SAND CREEK RESTORATION

PCD PROJECT NUMBER: CDR-20-004

PUBLIC IMPROVEMENT CONSTRUCTION PLANS

EPC STORMWATER REVIEW COMMENTS
 IN ORANGE BOXES WITH BLACK TEXT

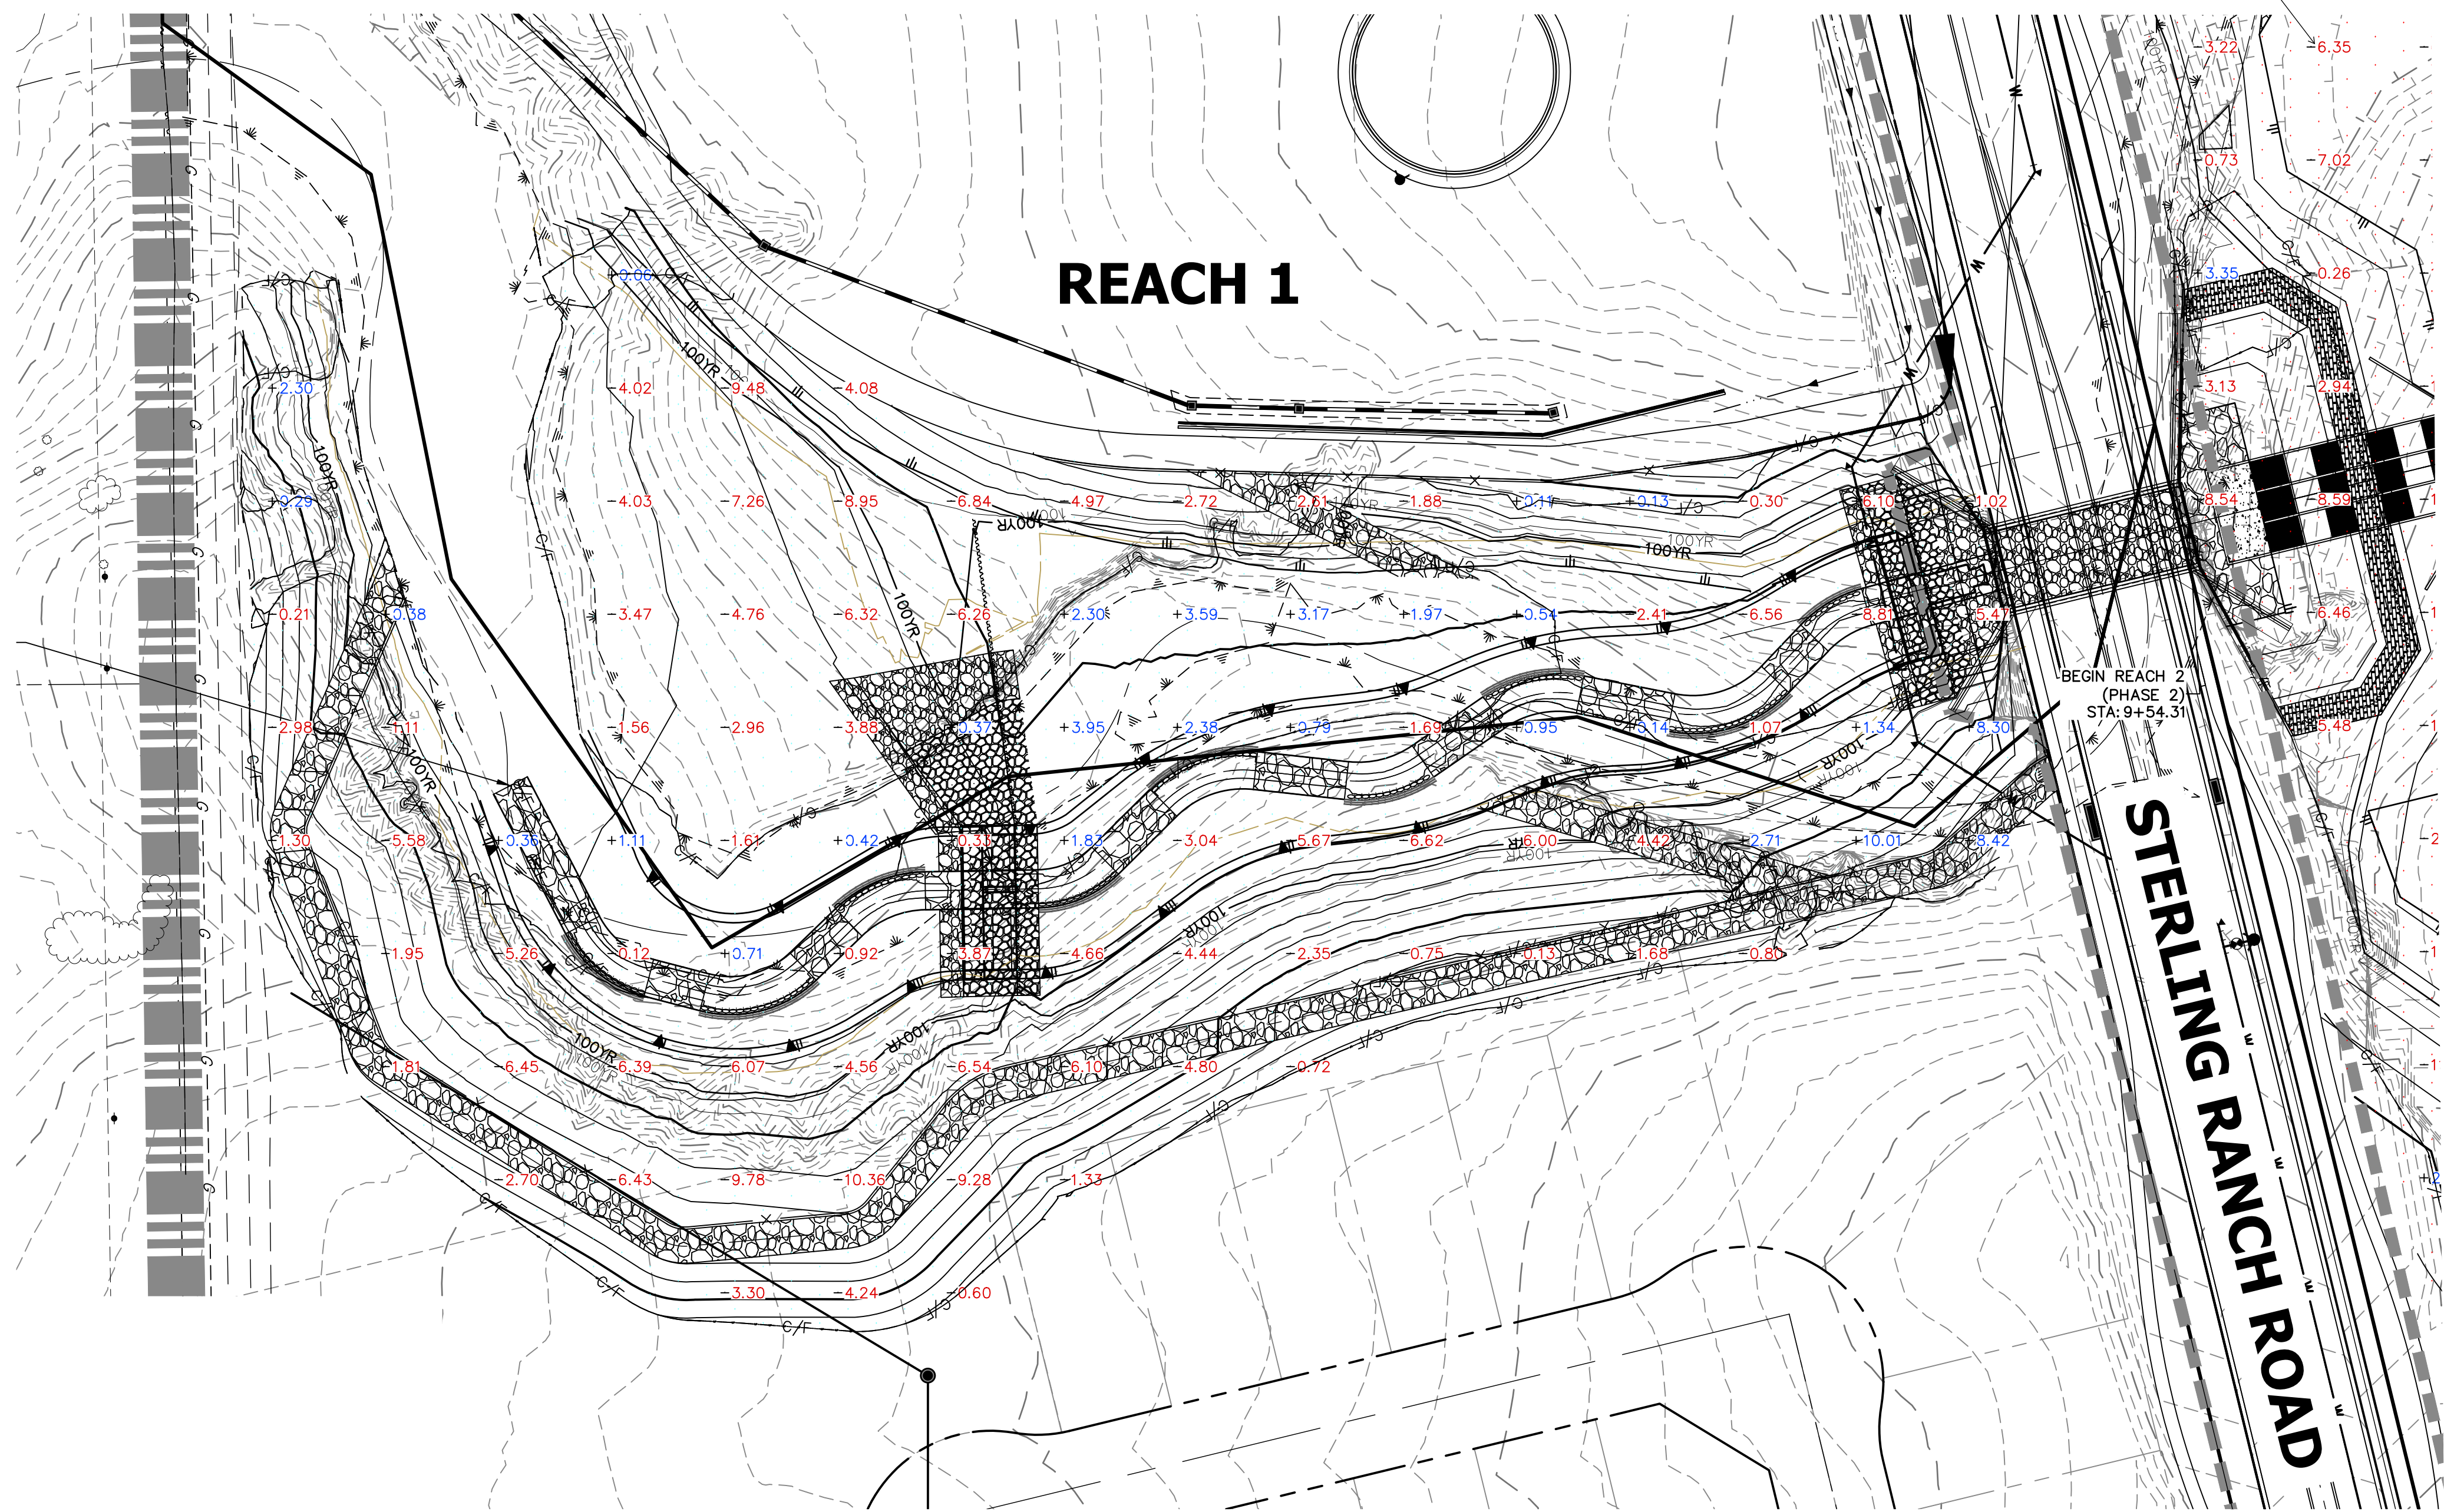
show on figure

JR-Addressed, hatching is shown in figure

SAND CREEK RESTORATION	DEMOLITION PLAN	SHEET 10 OF 99
	JOB NO. 25188.04

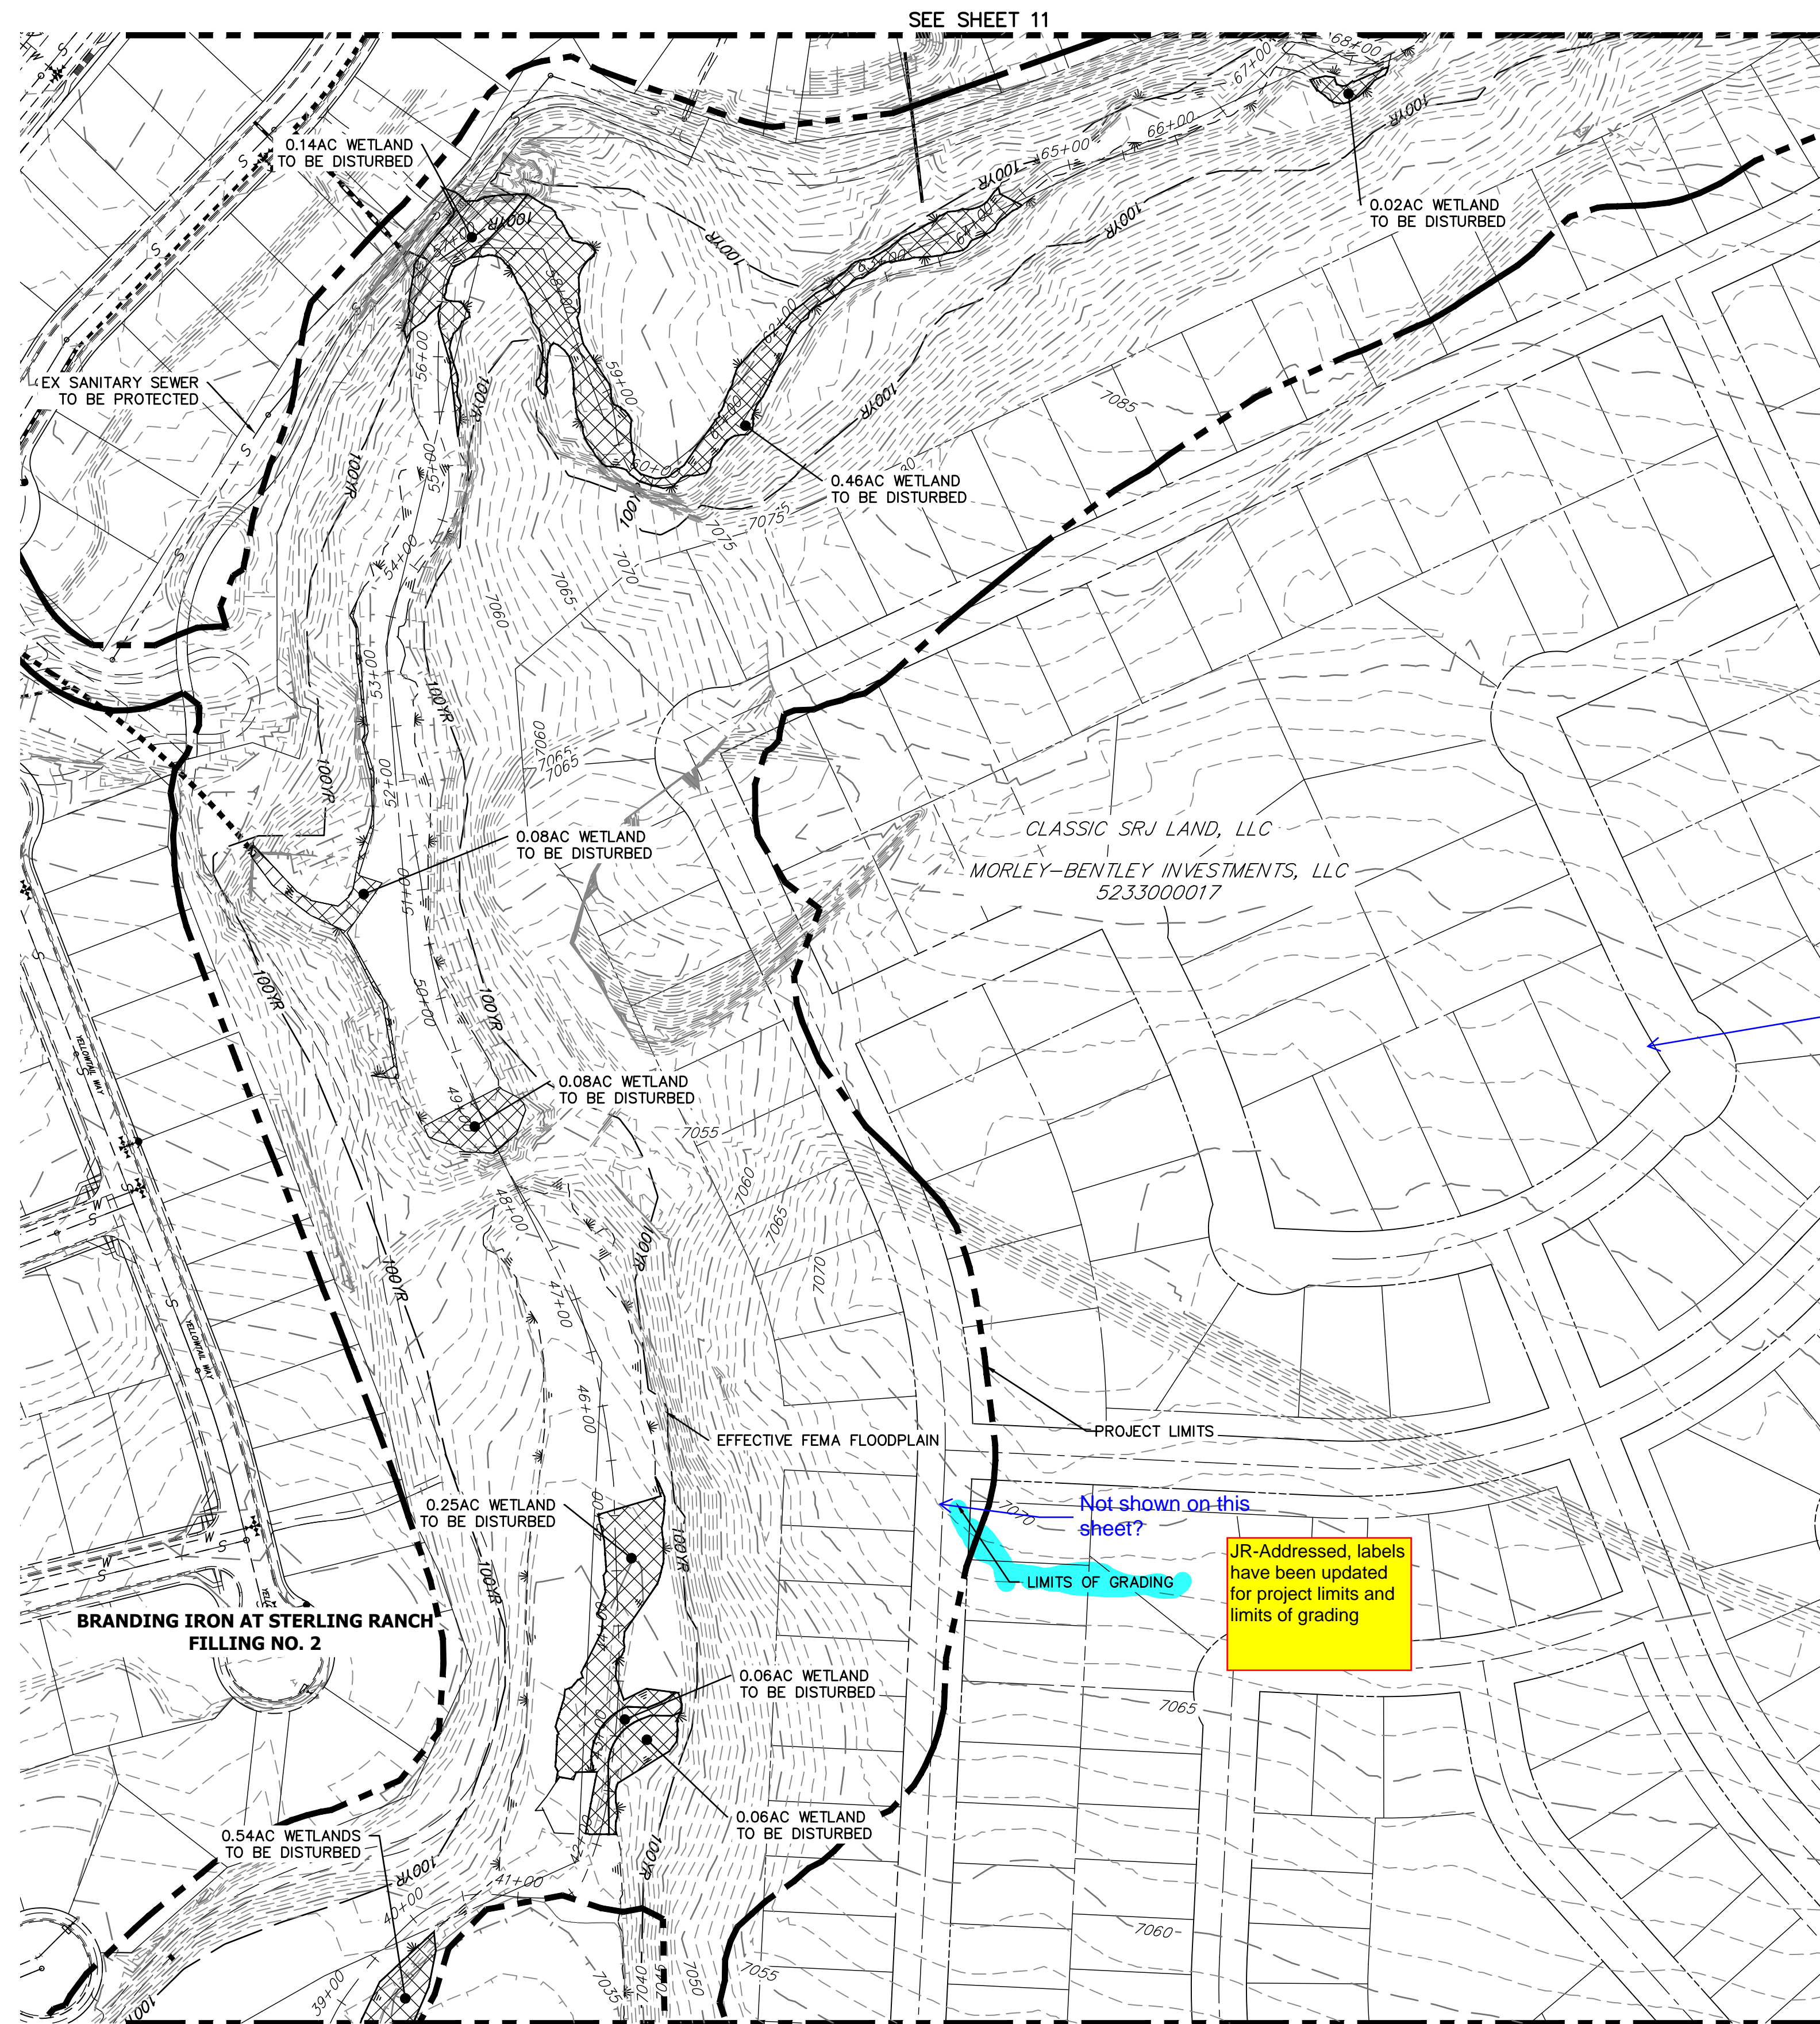
Turn off future lots or label and add a note that these are not approved.

Not shown on this sheet?

JR-Addressed, note added that future lots have not been approved

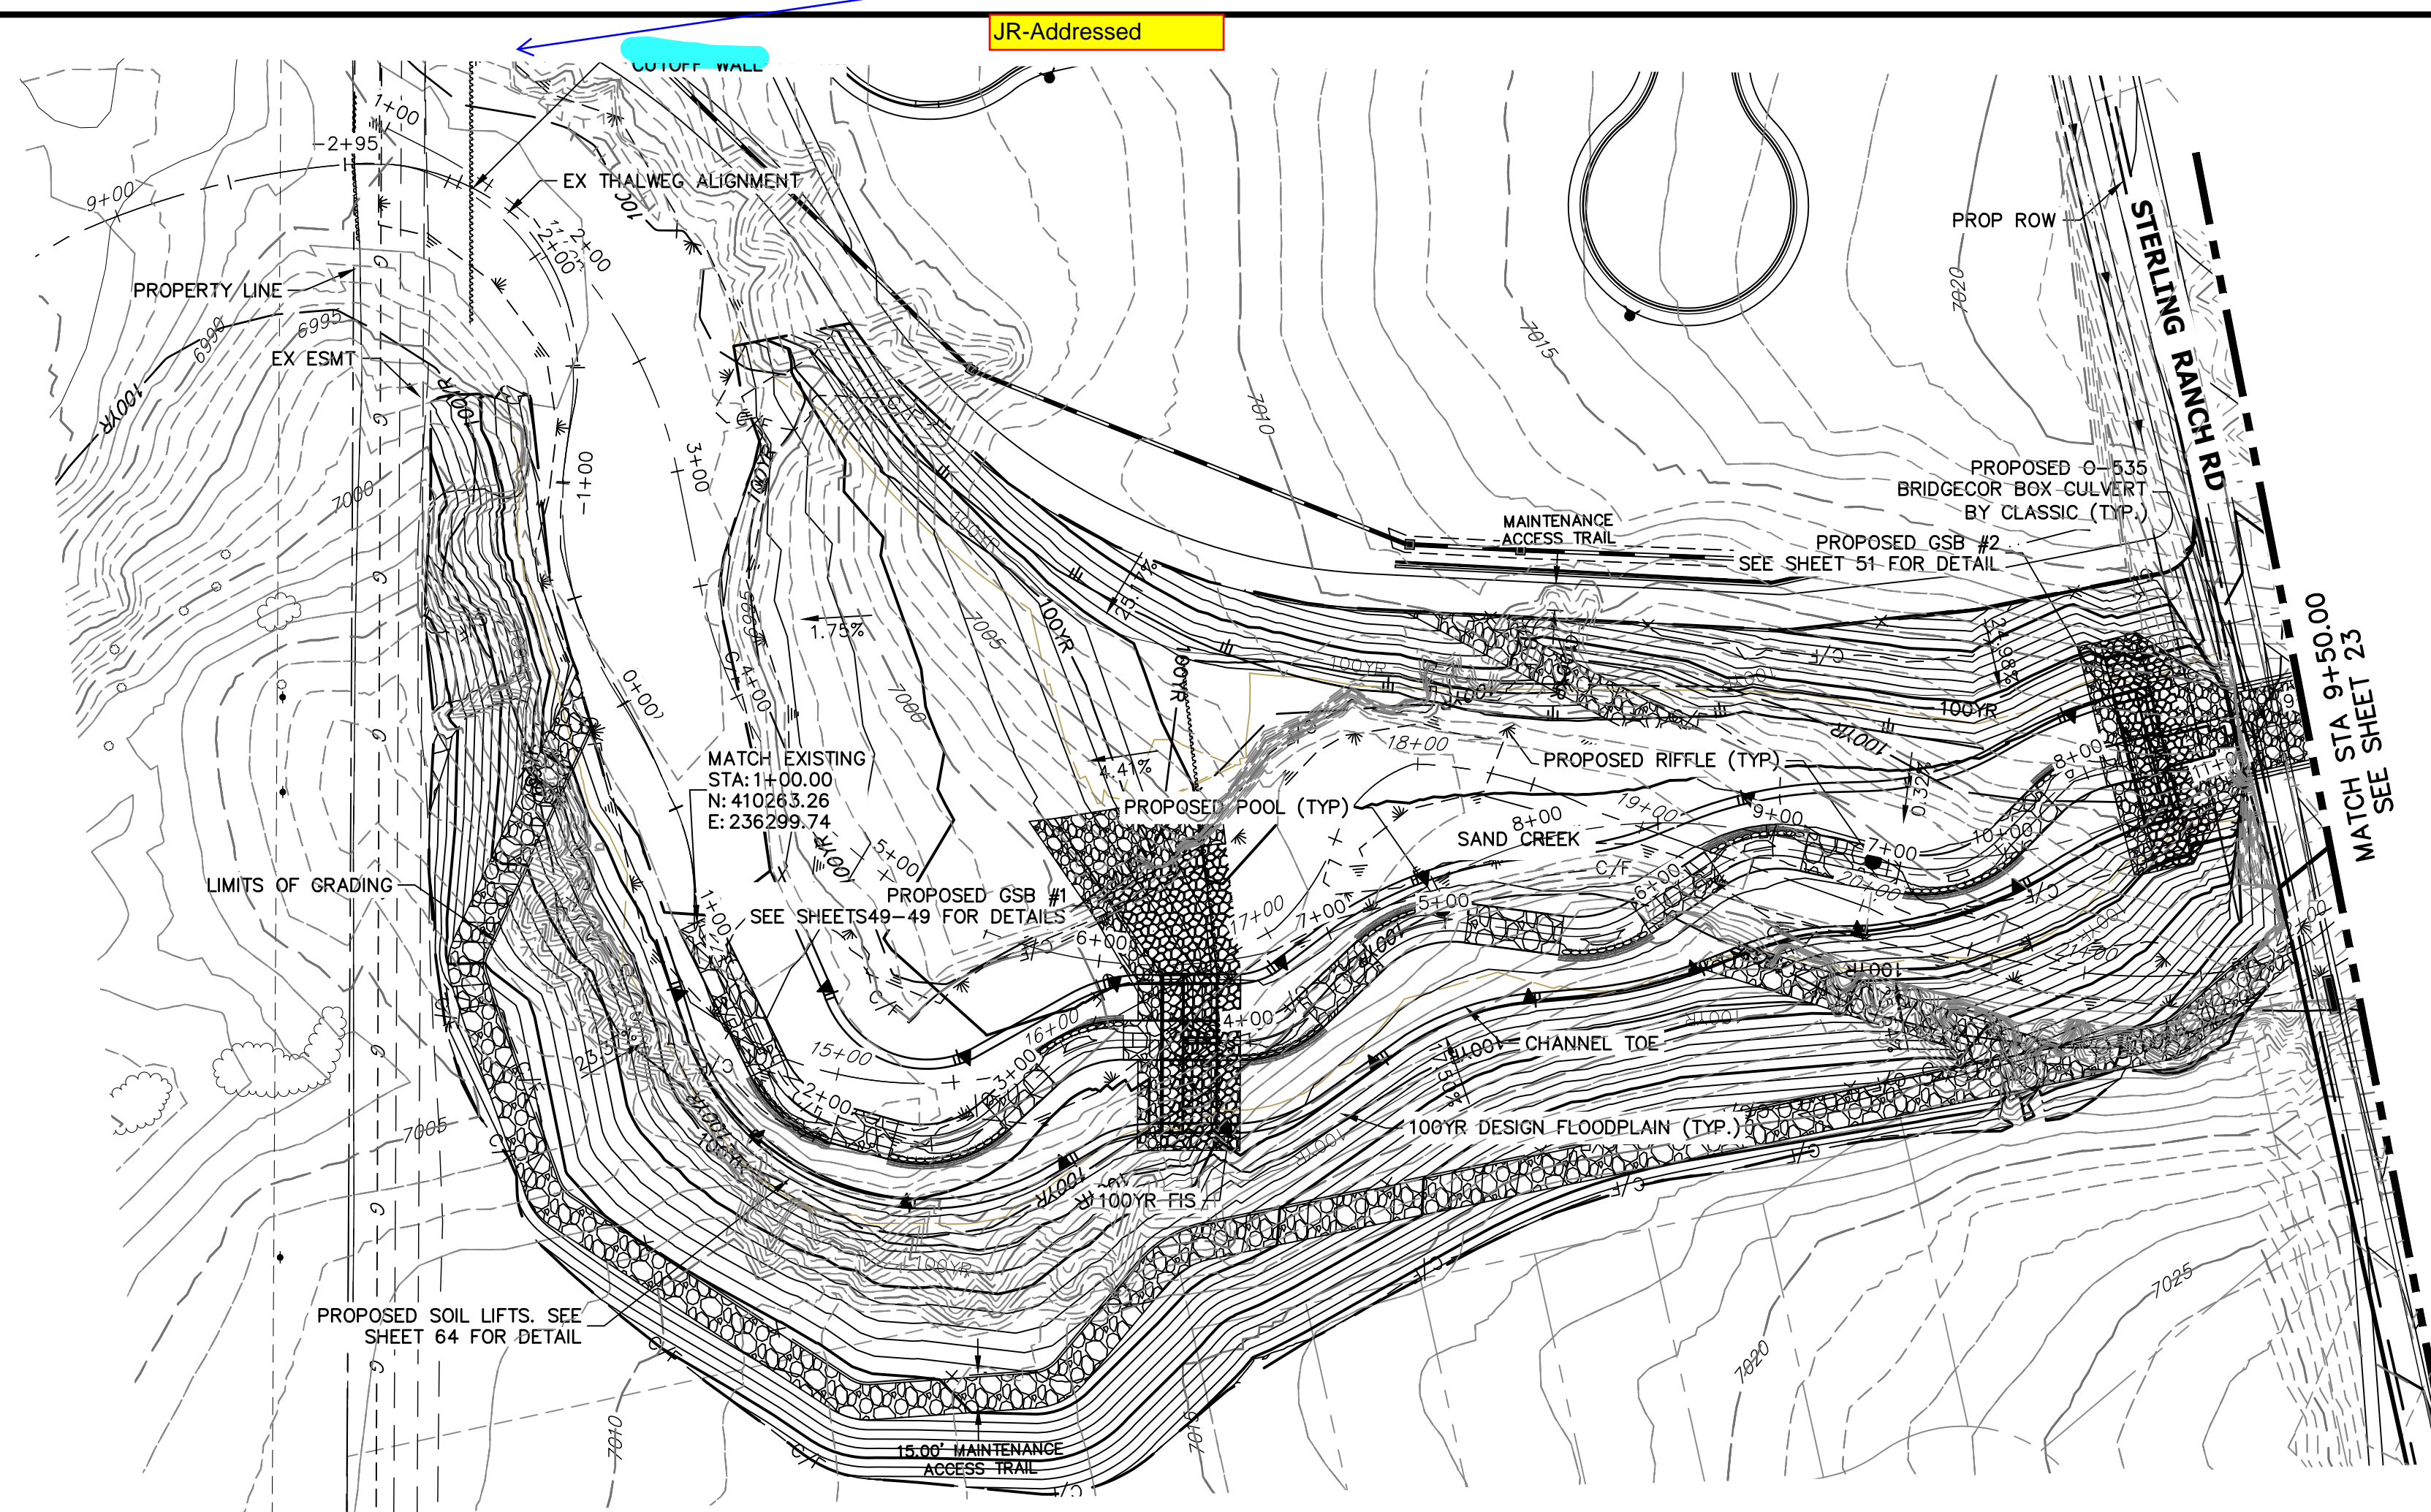
Adjust viewpoint

JR-Addressed Show property line and utilities

JR-Addressed delete gray line?

JR-Addressed, see Stable Grade Plan and Profile sheets 26-31

JR-Addressed, see Stable Grade Plan and Profile sheets 26-31
